Office Action Summary

10/563,040

BERTHOLD ET AL.

DETAILED ACTION

Figure 4: *Combination Circuit*

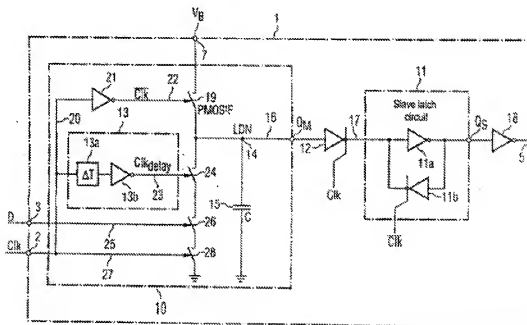
10. Claims 23-26, 28-34, 37-39 and 42 are rejected under 35 U.S.C. 103(a) as being unpatentable over Klass (US Patent No. 5,197,355). Please refer to the figures below:

11. For claim 23, Klass's invention comprises a signal delay circuit (INV1 and INV2, Figure 2 above) configured to generate a delayed clock signal (CKD, Figure 2 above) corresponding to the clock signal (CK, Figure 2 above) delayed by a time delay (INV1 and INV2 in Figure 2 above form a buffer with a fixed time delay) but fails to teach the said circuit node and capacitor with a programmable capacitance. However, examiner takes official notice that it is notoriously old and well known that a capacitor connected to ground at an output to any circuit serves as a filter. Therefore, it would have been obvious to one of ordinary skill in the art at the time of invention to include a capacitor directly connected between ground and node X of Klass's invention in order to filter

noise. Thus, the combination circuit of Klass's invention with the capacitor as described above (Figure 4) comprises a circuit node (X, Figure 4 above) arranged to charge a capacitor (C, Figure 4 above) in a charging phase in response to the clock signal being logically low (as explained below) and to discharge in an evaluation phase depending on a data signal in response to the clock signal being logically high and the delayed clock signal being logically high; and a capacitor with a programmable capacitance (see paragraph 4 of this action) coupling the circuit node (X, Figure 4 above) to a reference potential (ground). For Figure 4 above, when the clock signal is logically low, transistor P1 is on, allowing capacitor C to charge. The capacitor C discharges only when the clock signal (CK), input D, and the delayed clock signal (CKD) are all high.

12. For claim 24, the combination circuit of Figure 4 comprises a circuit node that is arranged to discharge a capacitor in the evaluation phase in response to the data signal being logically high and the circuit node is arranged to not discharge a capacitor in the evaluation phase in response to the data signal being logically low. As described above, the capacitor discharges when CK, CKD, and input D are high and charges when the signal CK is low. The charging of capacitor C does not depend on input D. Nonetheless, the capacitor C does not discharge when the data signal is low and CK is low.

13. For claim 25, the combination circuit of Figure 4 comprises a first isolating circuit (transistor N4, Figure 4 above) configured to be clocked by the clock signal and having an input connected to the circuit node (X, Figure 4 above).

14. For claim 26, the combination circuit comprises a slave latch circuit (INV7 and INV5) wherein the first isolating circuit has an output (drain of N4) connected to the slave latch circuit, the first isolating circuit configured to generate an output signal (Q) at the output, and the slave latch circuit is configured to buffer-store the output signal.

15. For claim 28, Figure 4 shows that the said signal delay circuit, the circuit node, and the capacitor are incorporated into a master latch circuit since the output X is inputted into the a second latch.

16. For claim 29, the combination circuit of Figure 4 teaches a first controllable switch that switches the operating voltage to the circuit node in response to the clock signal being logically low but fails to teach the inverter and first controllable switch driven by the inverted clock signal. However, examiner takes official notice that it is well known that a switch that is active low operates in the same manner as a switch that is active high which has an inverter connected to its control terminal. Therefore, it would have been obvious to one of ordinary skill in the art to substitute a PMOS transistor for the claimed first controllable switch driven by the inverted clock signal.

17. For claim 30, the combination circuit of Figure 4 comprises a master latch circuit which further includes a reference potential node (any node between ground and the source of transistor N3) configured to be coupled to the reference potential (ground); the master latch circuit further includes a second, third and fourth controllable switches, the first, second, third, and fourth controllable switches being connected in series with one another between a voltage supply (VDD) and the reference potential node.

18. For claim 31, the combination circuit of Figure 4 comprises a NAND gate within the master latch circuit which has a delayed clock signal and the output of the first controllable switch as inputs. Depending on the logic value of the output of the first controllable switch, the NAND gate will invert the delayed clock signal and send this signal to the gate of the second transistor (N1). Therefore, the master latch circuit is configured to generate a delayed inverted clock signal and to drive the second controllable switch with the delayed inverted clock signal.

19. For claim 32, in the combination circuit of Figure 4, the input signal D is connected to the gate of the third transistor (N2). Therefore, the third controllable switch (N2) is arranged to be driven by the data signal (D).

20. For claim 33, in the combination circuit of Figure 4, CK is connected to the gate of the fourth transistor (N3). Therefore, the fourth controllable switch (N3) is arranged to be driven by the clock signal.

21. For claim 34, in the combination circuit of Figure 4, the capacitor C is connected in parallel with N1, N2, and N3.

24. For claim 39, by inspection of Figure 4, the master latch circuit only receives a single supply voltage (VDD).
